AMENDMENT OF SOLICITATION/MODIFICATION OF CONTRACT

2. AMENDMENT/MODIFICATION NO.
P00009

The following change is made to the above numbered contract for Lake Pontchartrain, LA & Vicinity, HLP, London Avenue Outfall Canal, Parallel Protection, Mirabeau Avenue to Robert E. Lee Blvd., West Bank; Mirabeau Avenue to Leon C. Simon Blvd., East Bank Floodwall, Orleans Parish, LA, to make a waterproof connection between the siphon pipes and the I-Wall at the pumping station and the electrical cable tray penetrating the wall.

Lake Pontchartrain, Louisiana and Vicinity, High Level Plan,
London Avenue Outfall Canal, Parallel Protection,
Mirabeau Avenue to Robert E. Lee Blvd., West Bank;
Mirabeau Avenue to Leon C. Simon Blvd., East Bank Floodwall,
Orleans Parish, Louisiana
Contract Number DACW29-94-C-0079,
CIN 03
B & K Construction Co., Inc.

DESIGNED BY: B.D.	DATE: 02/94	PLOT SCALE: 12	PLOT DATE: 02/04/94
DRAWN BY: M.W.B.	CHECKED BY: B.D.	FILE NO. H-4-40295	
SUBMITTED BY: MICHAEL G. JACKSON, P.E.	SOLICITATION NO. DACW29-94-B-0047	DWG. 41 OF 73

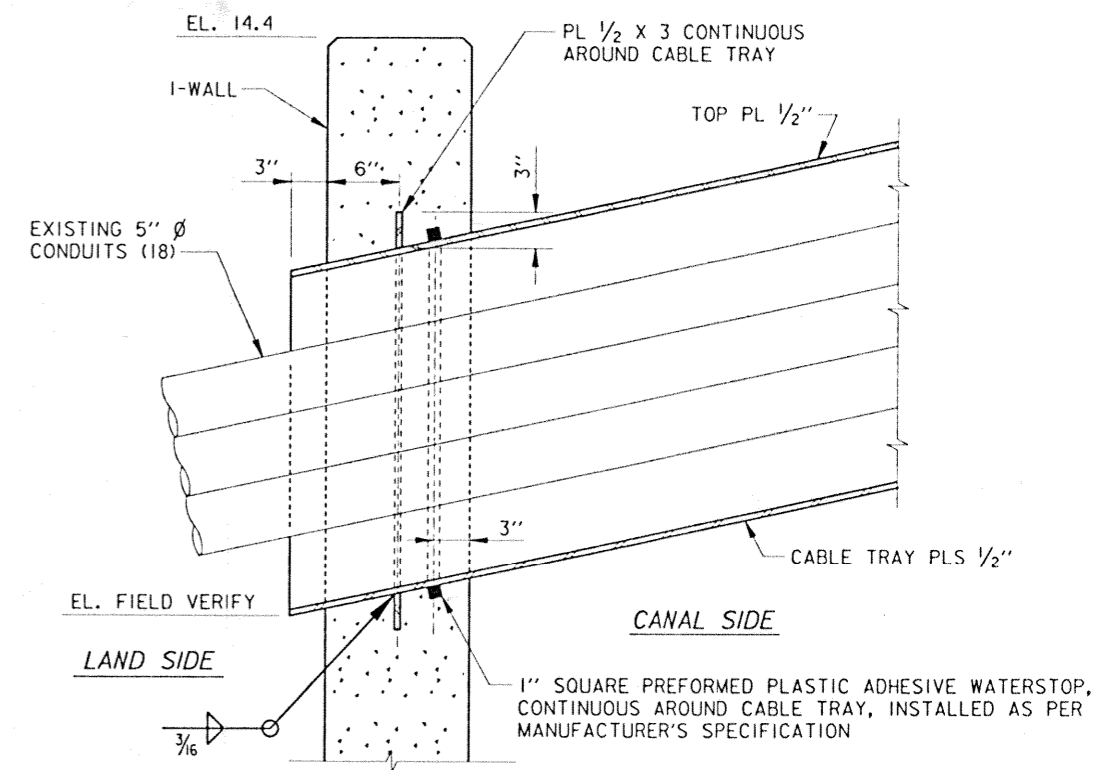
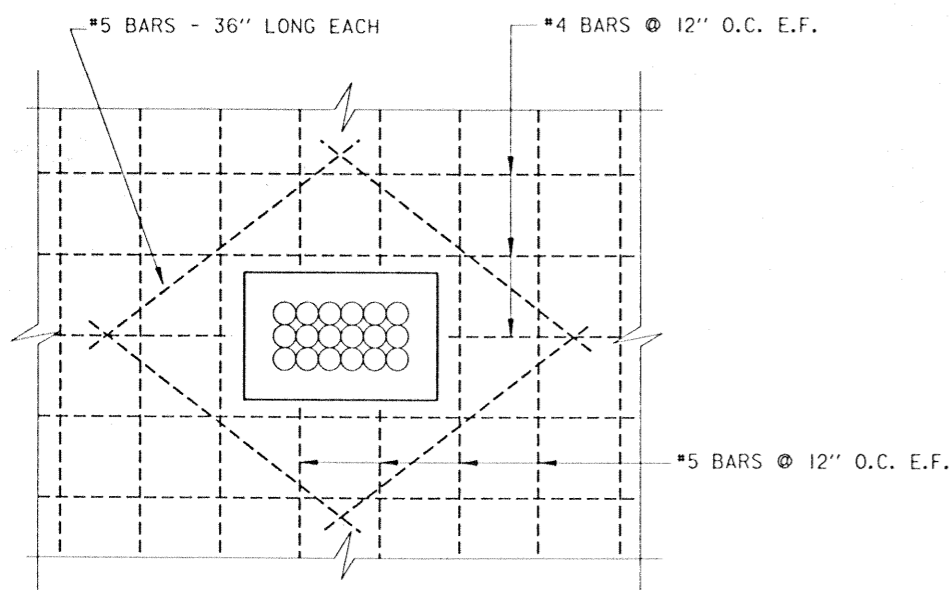
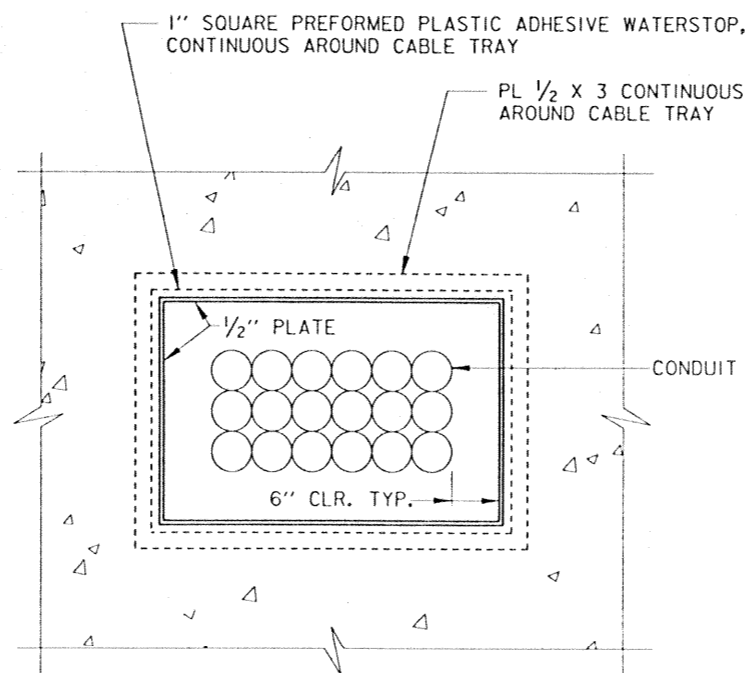
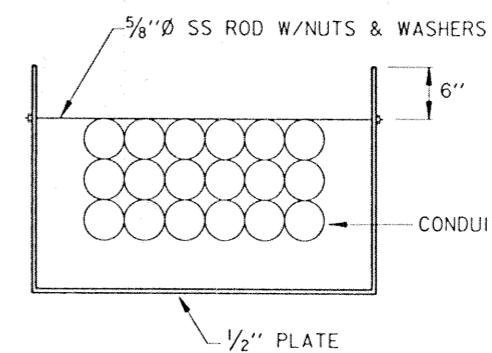
(1) The Change. Add a steel plate and plastic sealant to the pipe sleeve on the telephone cable crossing, TC-1.

b. Necessity for "OLD Change" passes through the I-sealant are needed to assure a watertight seal and pipe sleeve on TC-1.

a. Telephone Cable Tray: adding an anchor plate and a water stop on the periphery of the cable tray box as shown on the attached drawing 41 of 73, FILE NO. H-4-40295, bearing revision 1, dated February 3, 1995.

CHANGES TO THE CONTRACT DRAWINGS: Delete drawing 41 of 73, File No. H-4-40295, dated February 1994, and substitute with drawing 41 of 73, File No. H-4-40295, bearing revision 1, dated February 3, 1995.

WEST SIDE REINFORCEMENT DETAIL AT SIPHON CROSSING

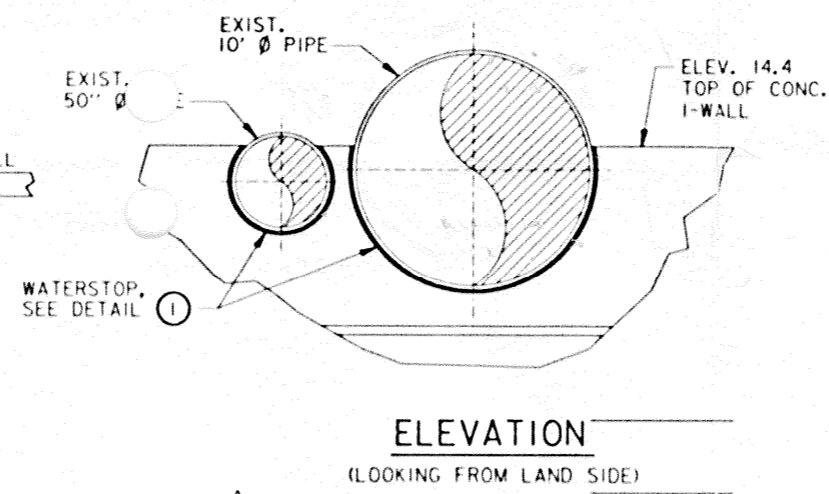
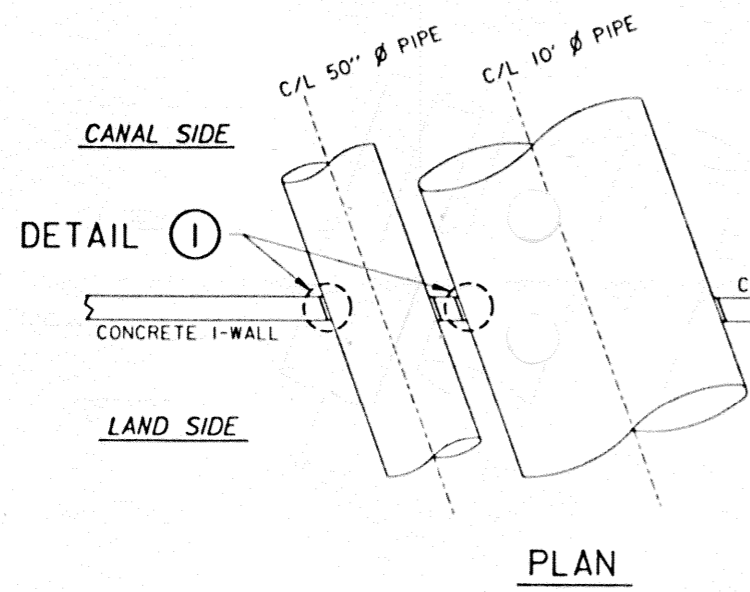
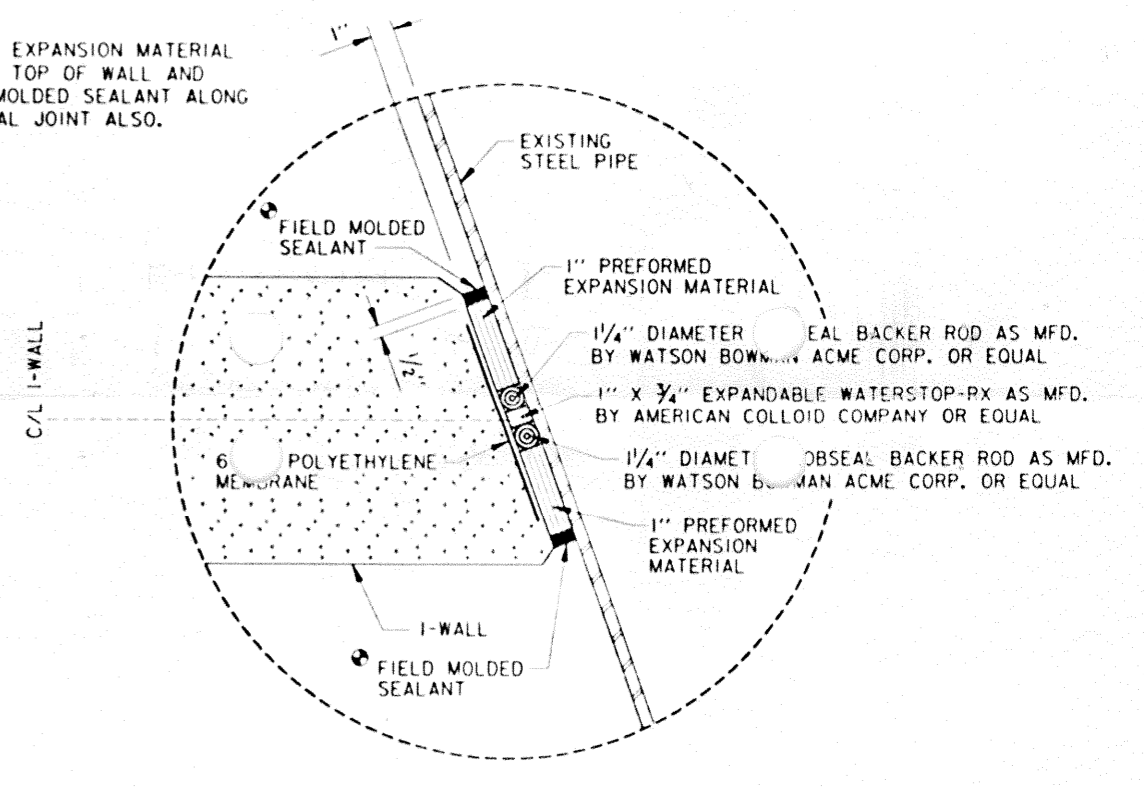
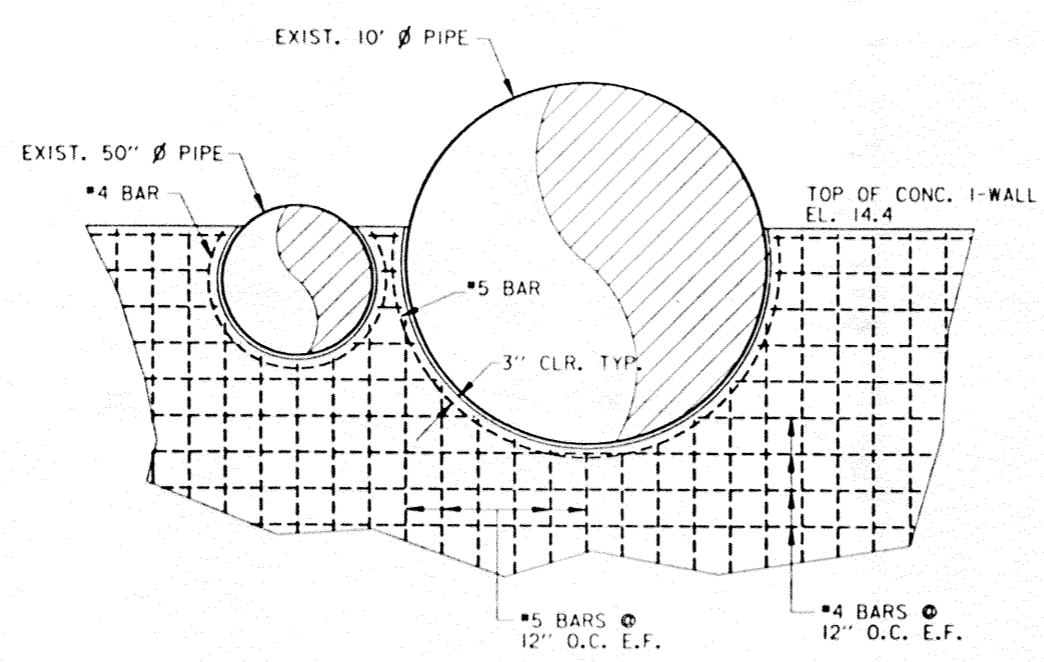
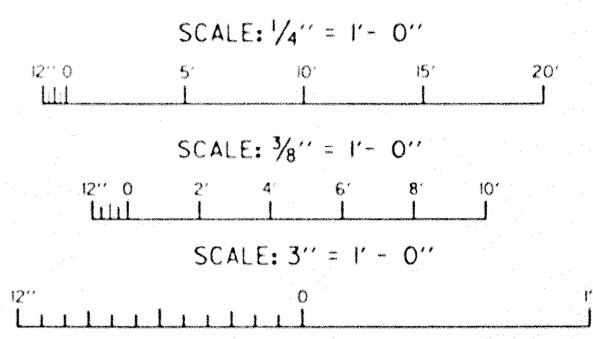
(1) The Change. Add expandable waterstops, expansion material, polyethylene membranes and backer rods to the pipe sleeves on the siphon and discharge tube crossings, ST-1 and DT-1.

b. Necessity for the Change. ST-1 and DT-1 pass through the I-wall at an angle. The existing L-type waterstop detail would require a specially fabricated waterstop. The new detail has only standard materials and will therefore be easier to acquire. The waterstops, expansion material, membranes, and backer bars are needed to assure a watertight seal between the I-wall and pipe sleeve on ST-1 and DT-1.

b. Siphon Crossing: adding a water stop between the siphon crossings and the concrete I-Wall as shown on the attached drawing 43 of 73, FILE NO. H-4-40295, bearing revision 1, dated March 27, 1995.

Delete drawing 43 of 73, File No. H-4-40295, dated February 1994, and substitute with drawing 43 of 73, File No. H-4-40295, bearing revision 1, dated March 27, 1995.

RECESS PREFORMED EXPANSION MATERIAL A 1/2" ACROSS THE TOP OF WALL AND APPLY THE FIELD MOLDED SEALANT ALONG THE TOP HORIZONTAL JOINT ALSO.

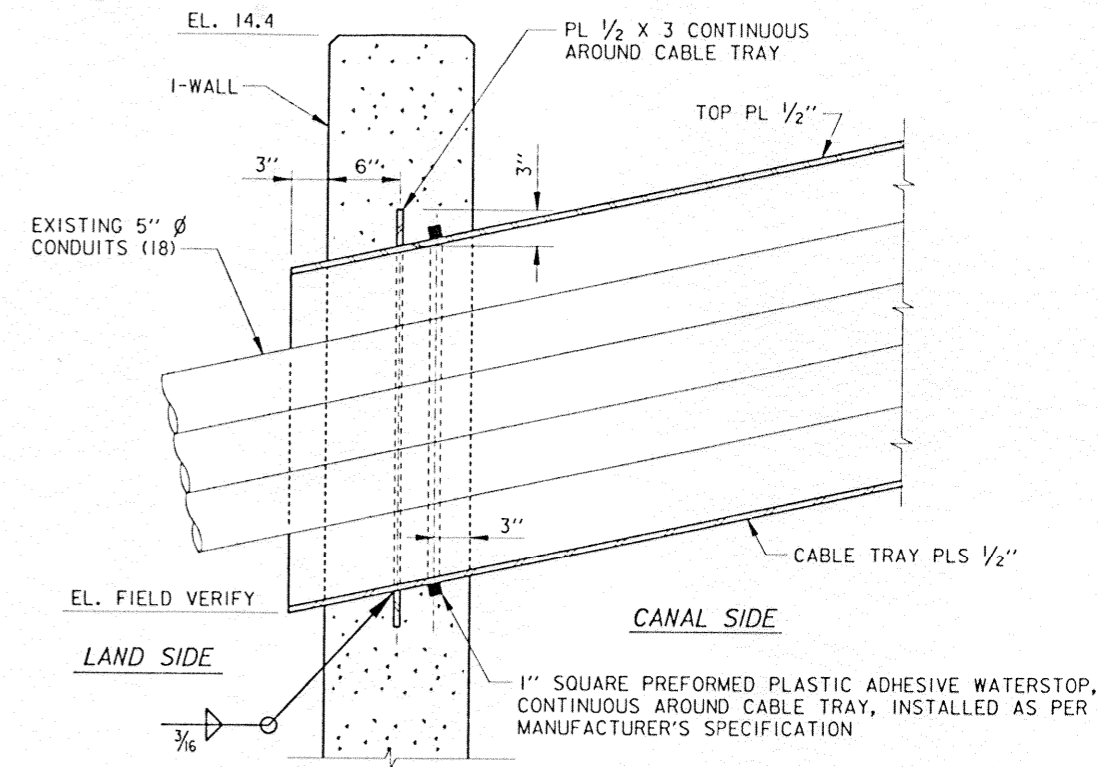
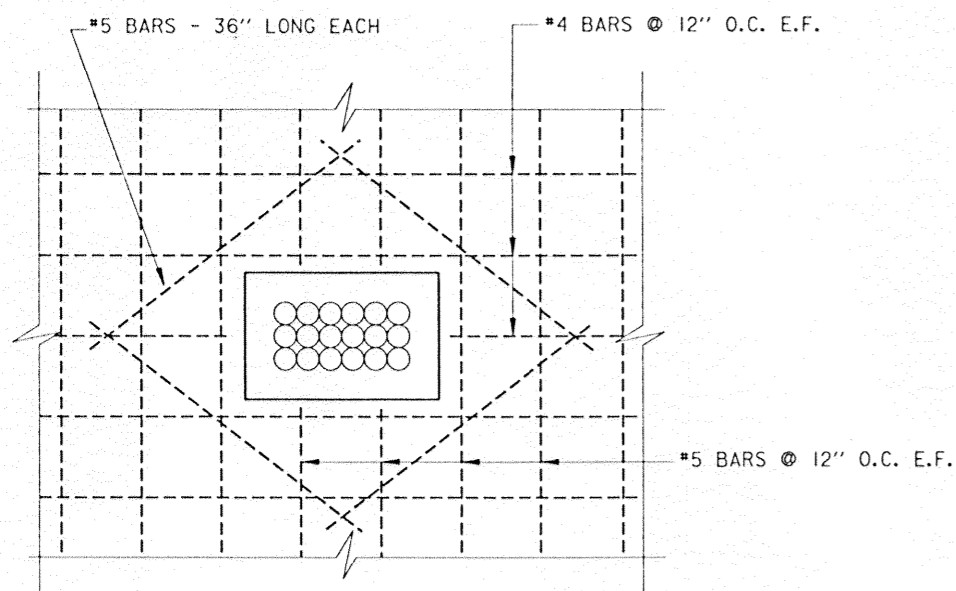
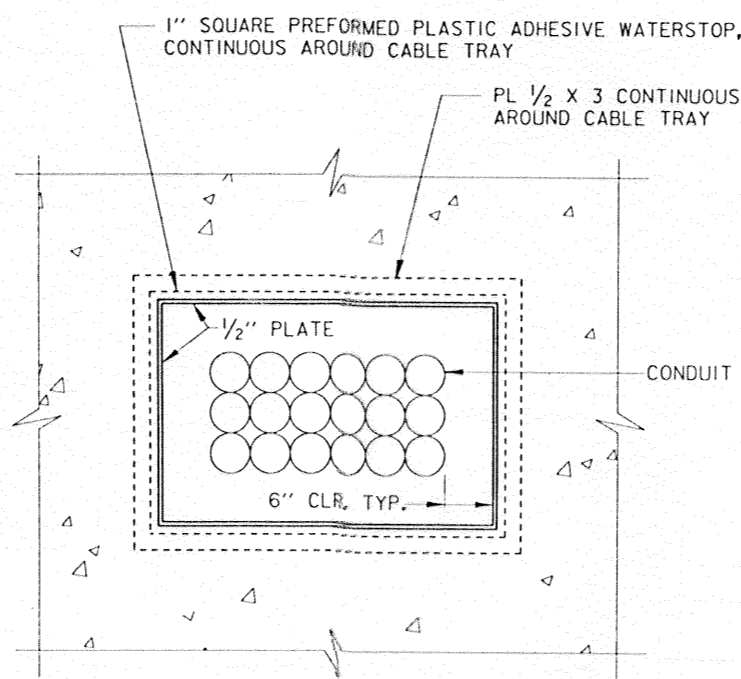
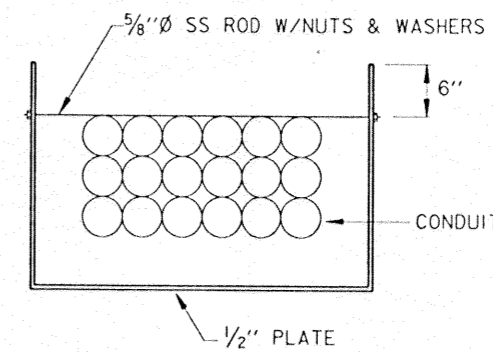
1" SQUARE PREFORMED PLASTIC ADHESIVE WATERSTOP, CONTINUOUS AROUND CABLE TRAY, INSTALLED AS PER MANUFACTURER'S SPECIFICATION

1. Delete drawing 41 of 73, FILE NO. H-4-40295, dated February 1994, and substitute with drawing 41 of 73, FILE NO. H-4-40295, bearing revision 1, dated February 3, 1995.
2. Delete drawing 43 of 73, FILE NO. H-4-40295, dated February 1994, and substitute with drawing 43 of 73, FILE NO. H-4-40295, bearing revision 1, dated March 27, 1995.

LAKE PONTCHARTRAIN, LA. AND VICINITY
 HIGH LEVEL PLAN
 LONDON AVE. OUTFALL CANAL, PARALLEL PROTECTION
 MIRABEAU AVE. TO ROBERT E. LEE BLVD., WEST BANK
 MIRABEAU AVE. TO LEON C. SIMON BLVD., EAST BANK
 ORLEANS PARISH, LOUISIANA
SIPHON CROSSING DETAILS
 WEST SIDE

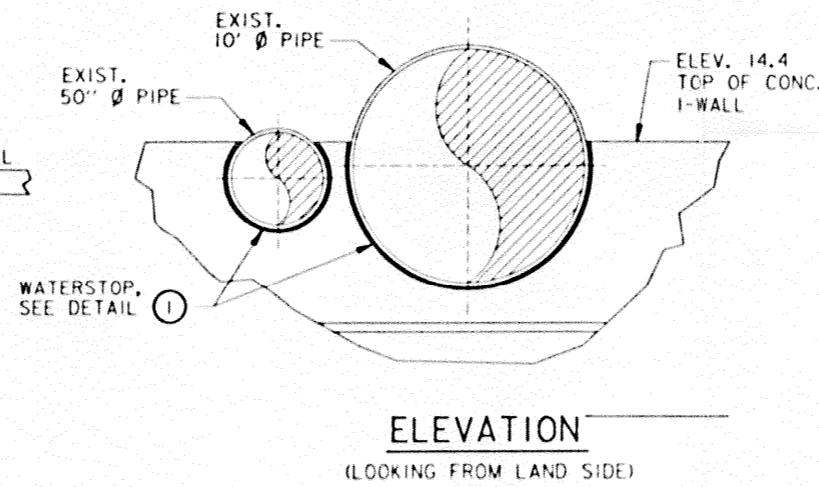
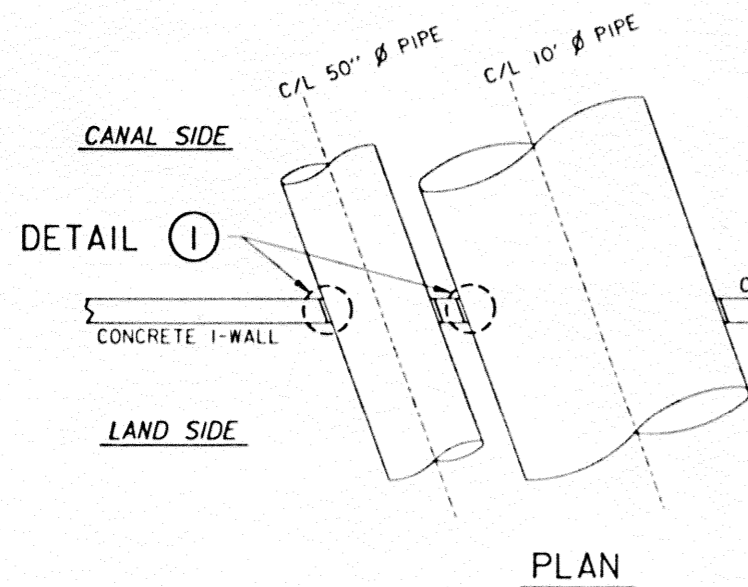
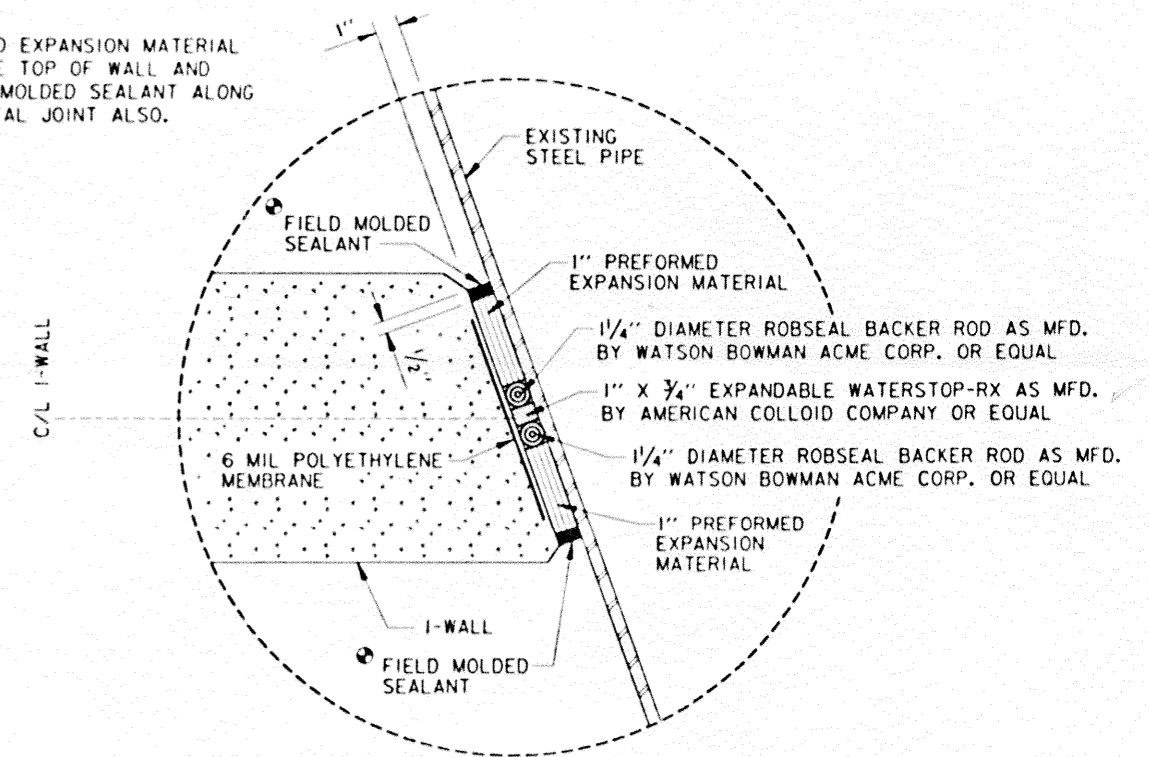
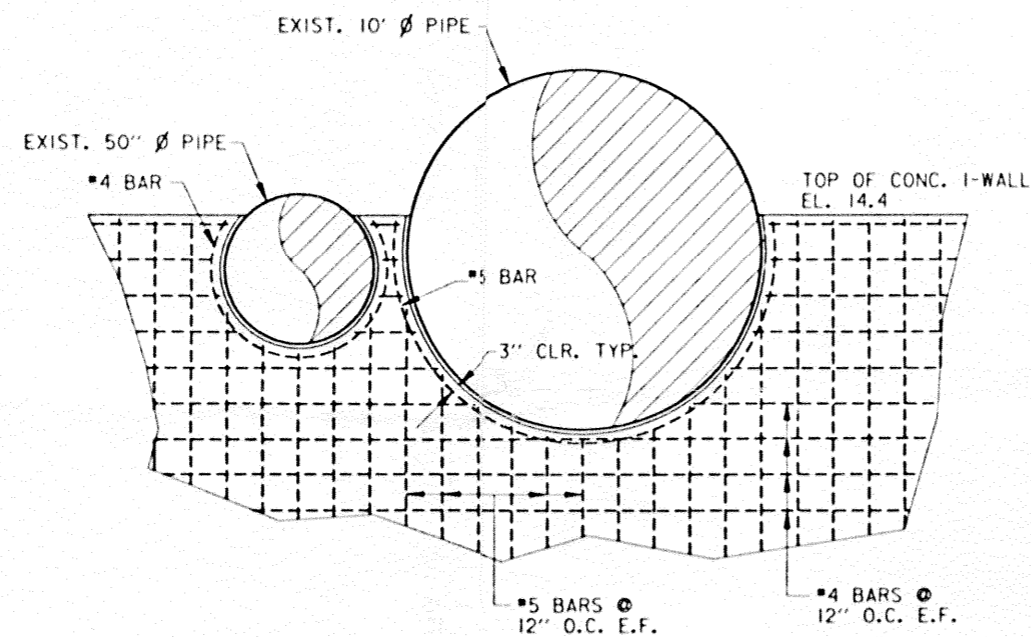
RECESS PERFORMED EXPANSION MATERIAL A 1/2" ACROSS THE TOP OF WALL AND APPLY THE FIELD MOLDED SEALANT ALONG THE TOP HORIZONTAL JOINT ALSO.
